Amendments to the Drawings:

Appl. No. 09/977,734
 Amdt. Dated Feb. 25, 2004
 Reply to Office Action of Jan. 15, 2004
 Replacement Sheet

Fig. 1

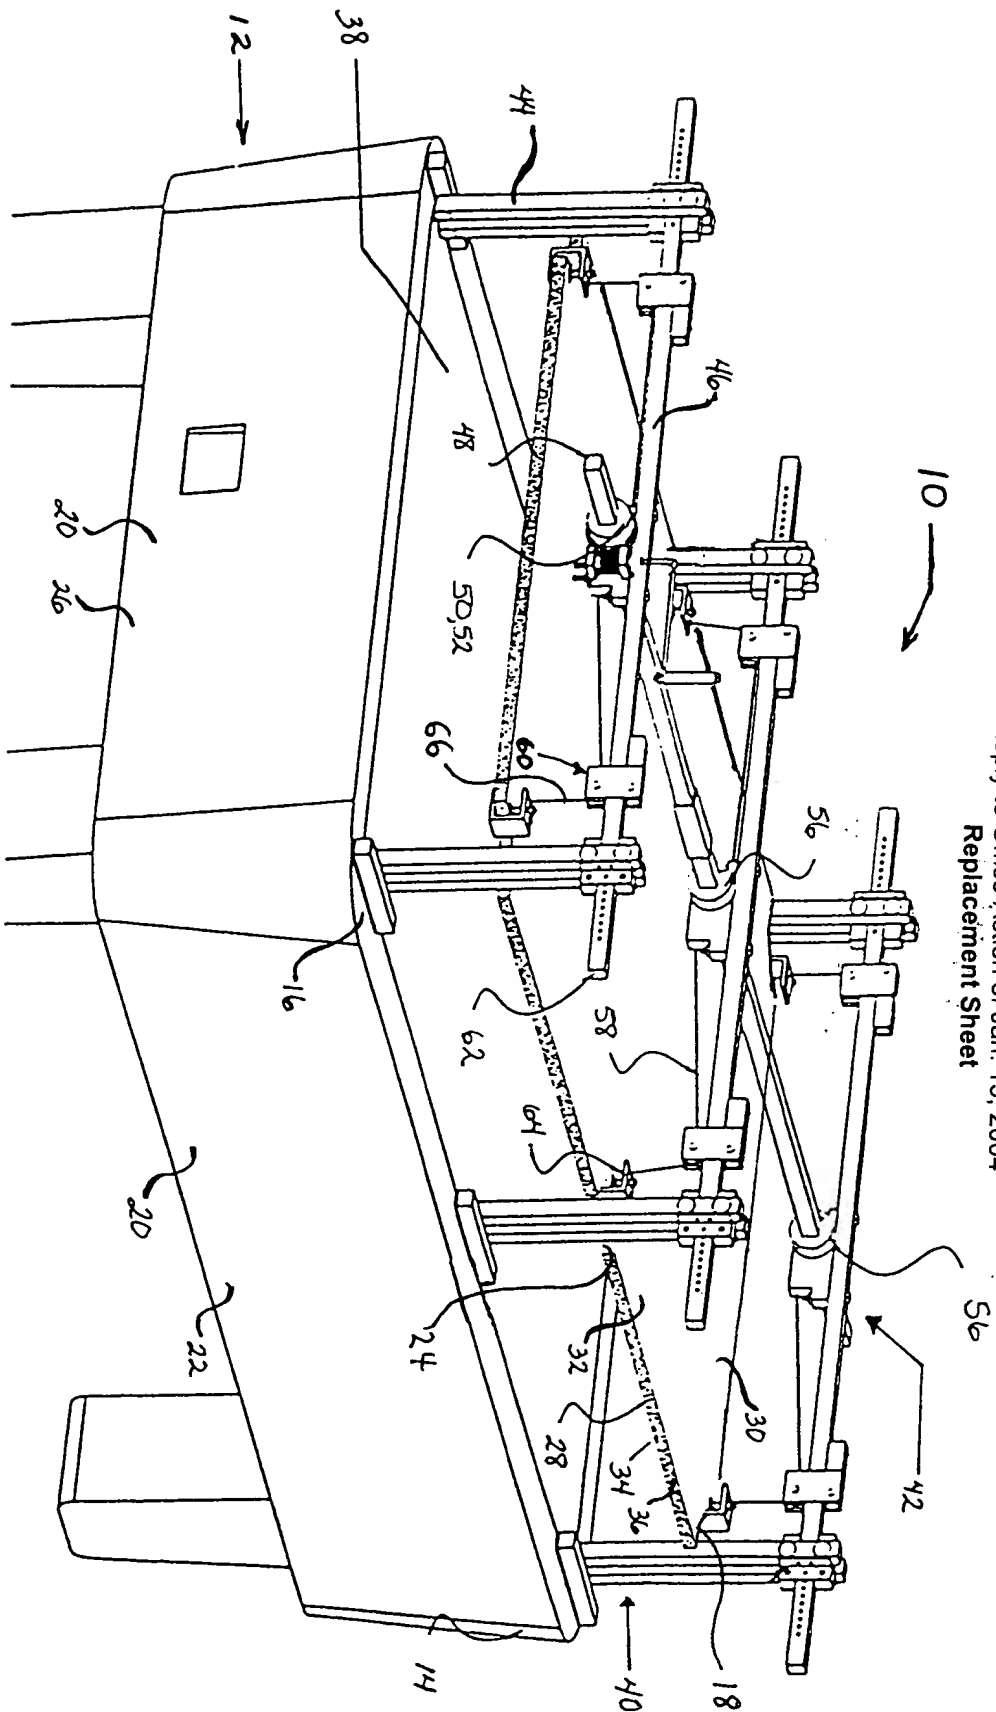
The attached sheets of drawings include changes to Figs. 1-4. The sheets containing Figs. 1-4 replace the original sheets that included Figs. 1-4. In Fig. 1, references to cable protruding end 66 and pockets 18 and 24 have been added. In Fig. 2, reference to element side support bracket brace 78 has been added, and the number identifying adjustment hole 76 has been corrected by replacing the incorrect number, 86. In Fig. 3, references to cable protruding end 66 and crank 82 have been added, and reference 78 has been deleted. In Fig. 4, reference to element 32 has been deleted.
